World Forum for Harmonization of Vehicle Regulations

Proposal for Supplement 5 to the 04 series of amendments to Regulation No. 44 (Child restraint systems)

Submitted by the Working Party on Passive Safety *

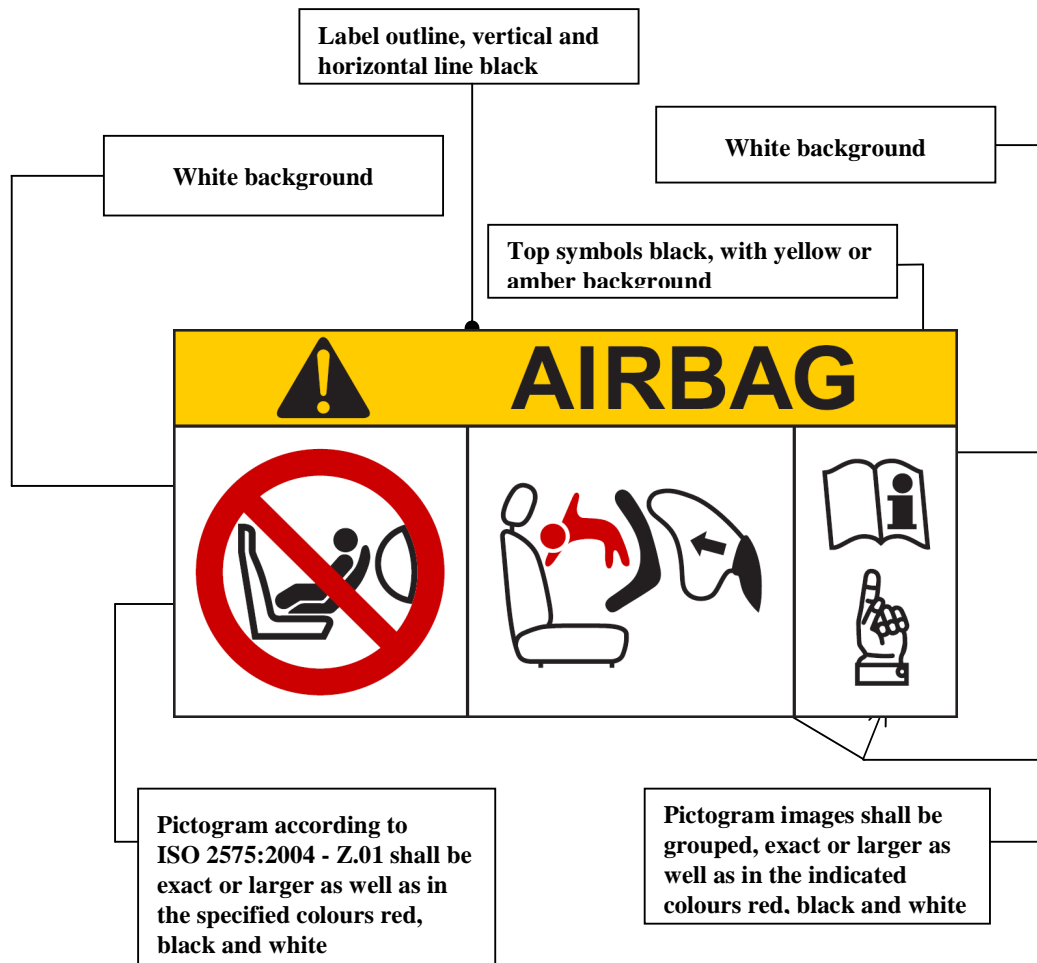
Insert a new paragraph 4.4., to read:

"4.4. On the visible inner surface (including the side wing beside the child's head) in the approximate area where the child's head rests within the Child Restraint System, rearward facing restraints shall have the following label permanently attached (the information shown is a minimum).

Label minimum size: 60 x 120 mm.

The label shall be stitched to the cover around its entire perimeter and/or permanently bonded to the cover over its entire back surface. Any other form of attachment that is permanent and not liable to removal from the product or to becoming obscured is acceptable. Flag type labels are specifically prohibited.

If sections of the restraint or any accessories supplied by the Child Restraint System manufacturer are able to obscure the label an additional label is required. One warning label shall be permanently visible in all situations when the restraint is prepared for use in any configuration.

"4.8. ISOFIX Marking

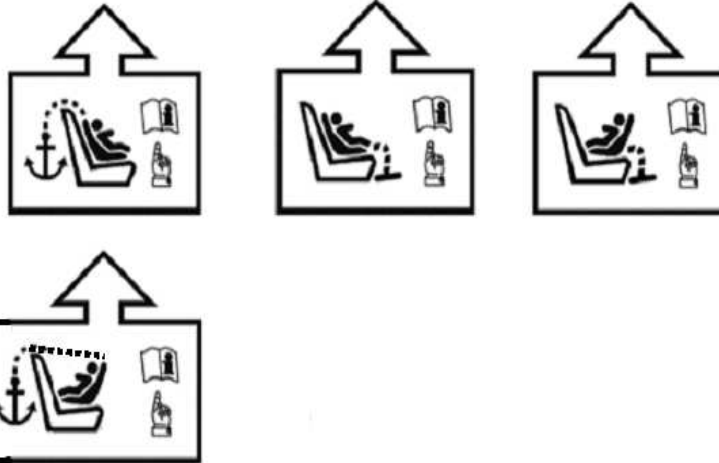
Paragraph 4.8., amend to read:
